FORD:

2013-2014 Fusion

2013-2014 MKZ

This article supersedes TSB **13-10-14** to update the Service Procedure.

Figure 1 - Article 14-0005

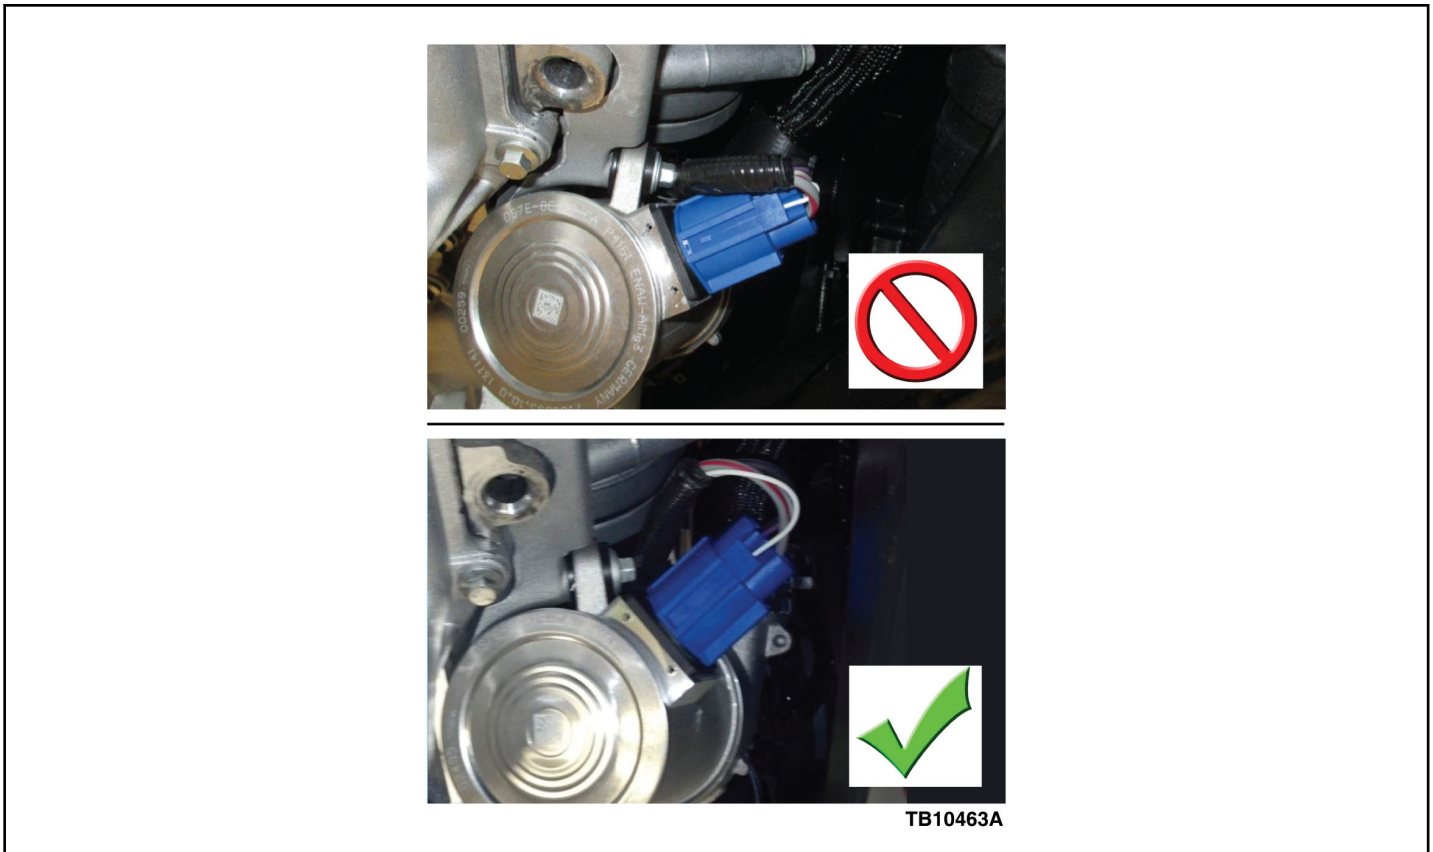
1. Disconnect C1812 at the coolant pump and inspect for evidence of moisture or corrosion on the harness connector and coolant pump terminals. Refer to Wiring Diagram, Section 33-1. Is moisture or corrosion present?
 - a. No - this article does not apply. Refer to the Powertrain Control/Emissions Diagnosis (PC/ED) manual for normal diagnosis.
 - b. Yes - proceed to Step 2.
2. Replace the coolant pump. Refer to Workshop Manual, Section 303-03.
3. Replace the coolant pump connector with a pigtail kit following instructions included in the kit.
 - a. Circuit SBF05 GY-RD to the coolant pump is hot at all times. Disconnect the 12 volt battery. Refer to Workshop Manual 414-01.
 - b. When installing the connector onto the coolant pump, ensure the harness is routed as straight as possible to avoid damage to the connector seal. (Figure 1)
